**ZONING AMENDMENT
& SUBDIVISION STAFF REPORT****Date: November 6, 2014****APPLICANT NAME**

Bean Industrial Subdivision

Subdivision approval to create 2 legal lots of record, and Zoning approval to rezone the site from R-1, Single-Family Residential District, to I-2, Heavy Industry District to allow a proposed steel warehouse and service center.

SITE PLAN

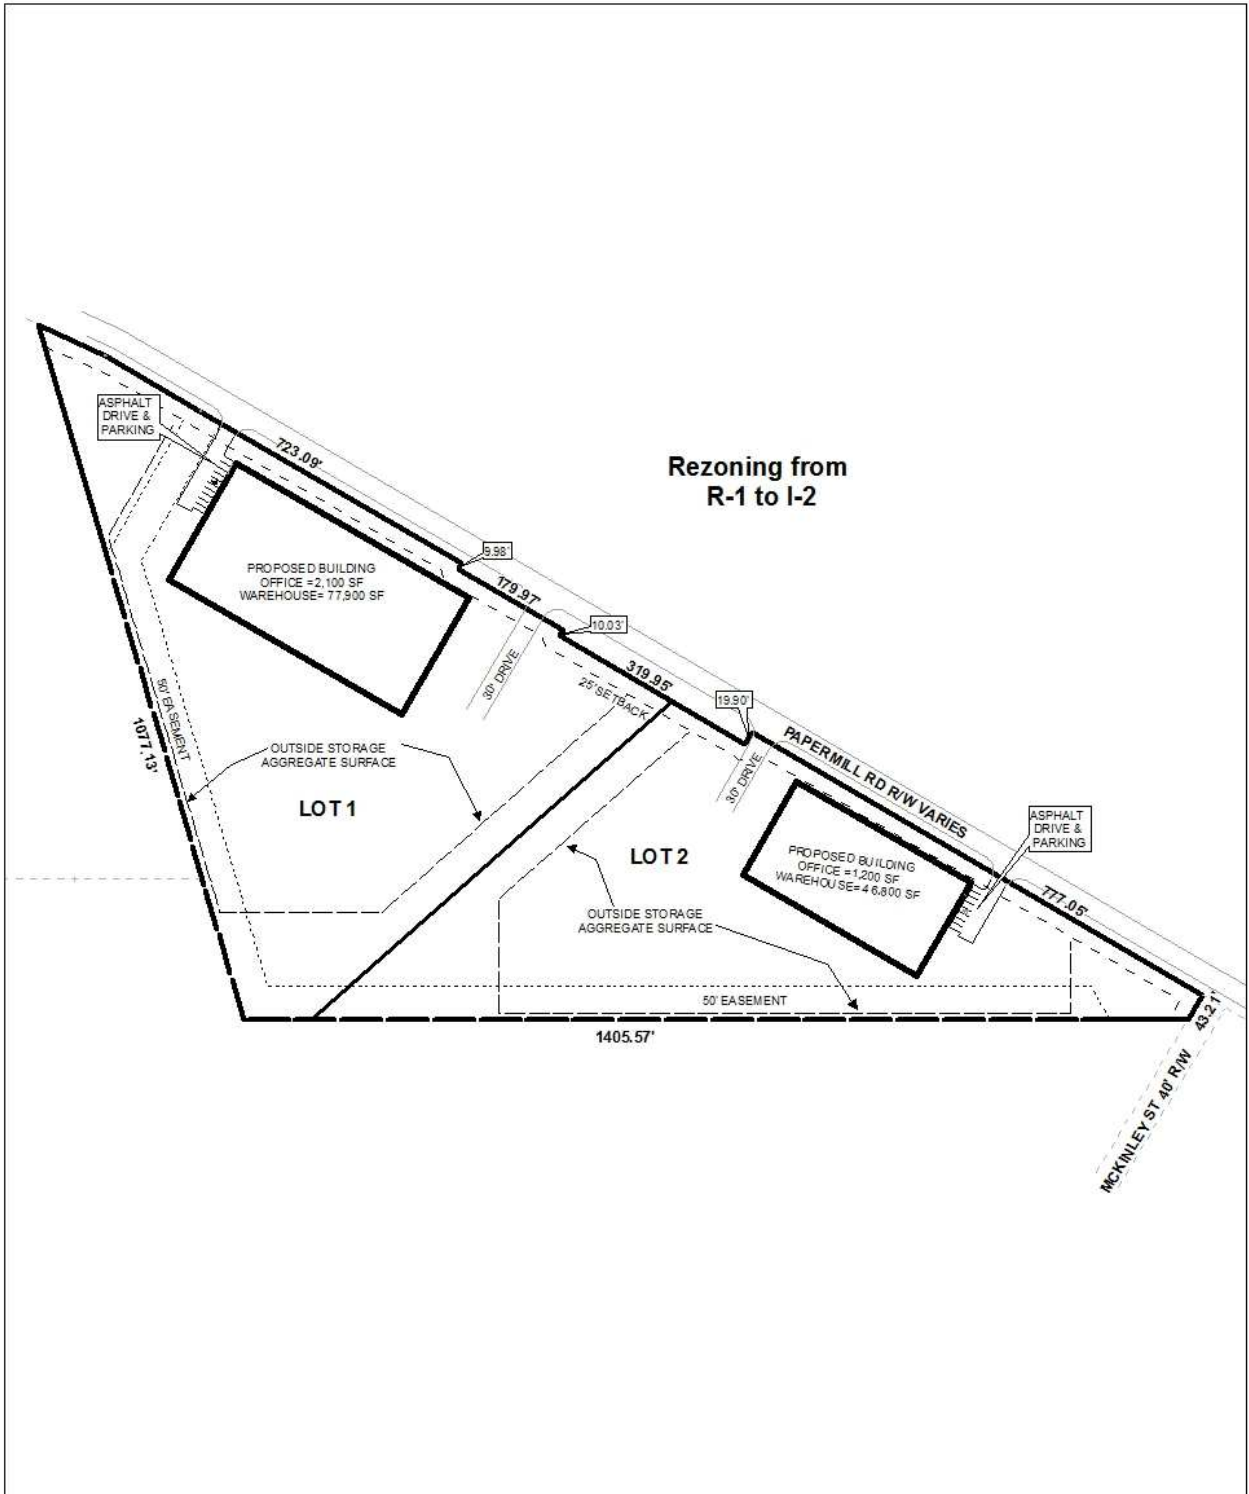
The applicant proposes that each proposed lot have a building consisting primarily of warehouse space, with offices. Based on the number of warehouse employees provided for each proposed lot, the required number of parking spaces is provided. The proposed site plan illustrates outside storage to have aggregate surfacing, which is allowed by right in an I-2, Heavy Industry District.

It should be noted that there is no clearly demarcated separation depicted on the provided site plan between the two lots, although the site plan does depict the limits of aggregate area, and there appears to be a 100-foot wide area along the common property line that would appear to be undeveloped. If, in fact, there will be access across the common property line, a Planned Unit Development application will be required.

The proposed site plan illustrates an 8' fence around the perimeter, but does not state if the fence will be chain link, wood or a wall. It should be noted that the storage yard area must be enclosed within a solid wall or fence at least 8' high. The fence should enclose the entire outside storage area and comply with the Zoning Ordinance requirements for a contractor's storage yard.

While the site plan does not illustrate tree plantings, it does make note that compliance with frontage trees will be provided. No mention of landscaped area to be provided is made, but it should be noted that full compliance with landscaped area will be required. However, the site plan does appear to depict development of an existing low area near the proposed common lot line. This 100-foot wide area should be left in its natural vegetative state if, in fact, there is no intention to develop the area.

No sidewalk is illustrated on the proposed site plan. A sidewalk will be required, unless a Sidewalk Waiver application is approved by the Planning Commission.
